Providence City Plan Commission

AGENDA ITEM 4 ■ 663 ADMIRAL STREET

OVERVIEW

South and east building elevations

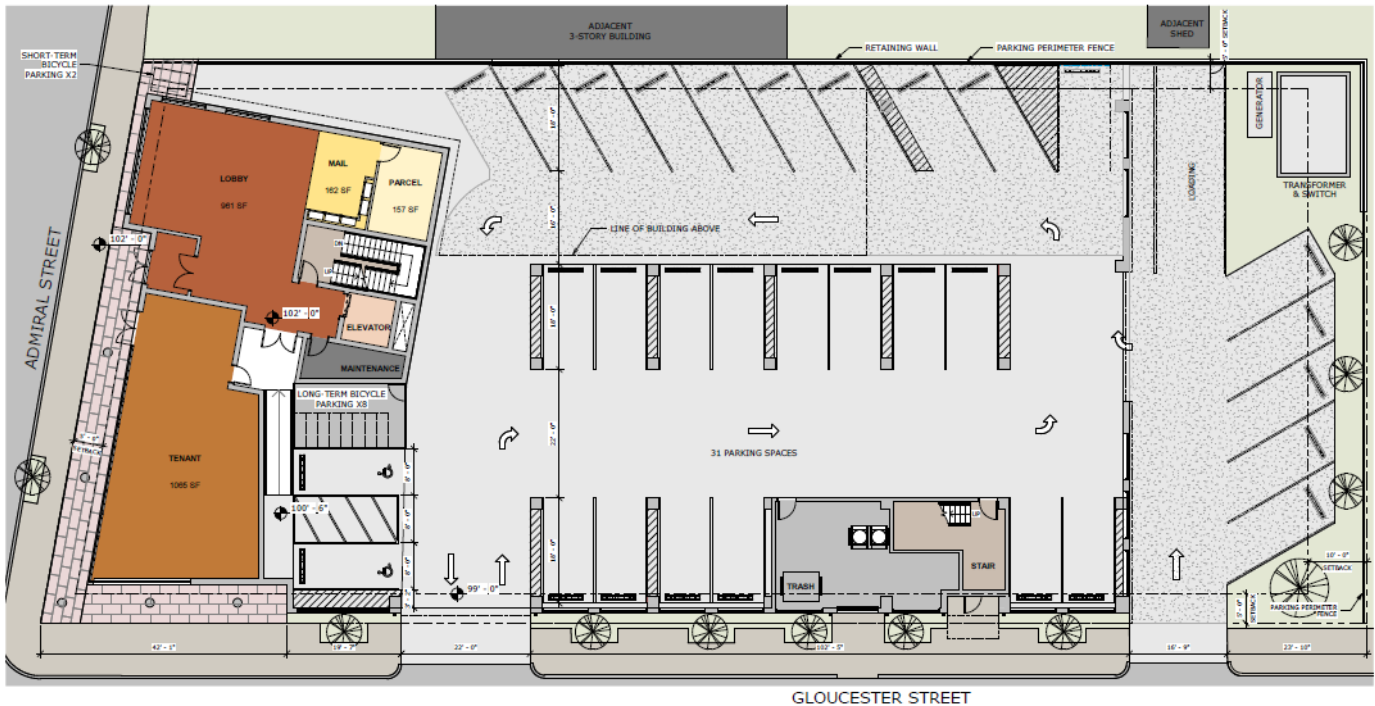
Forty eight units will be located on the four upper stories. Based on provided plans, the building will conform to the design guidelines for multifamily development outlined in Section 1202 K of the ordinance. The design employs a varying, but consistent treatment for the exterior with two prominent projections on the façade on the second through fourth stories with the rest of the façade set back. The façade will mainly employ brick on the ground floor with wood siding, fiber cement and metal panels on the upper stories. The materials are permitted by right in the C-1 zone.

The ground floor frontage will be located within the five foot build-to zone. The majority of the upper stories will be located at the lot line, with some portion encroaching over the sidewalk, for which encroachment permits are required. Over 50% of the ground floor will be transparent, with fenestration on the upper stories greatly exceeding 10%.
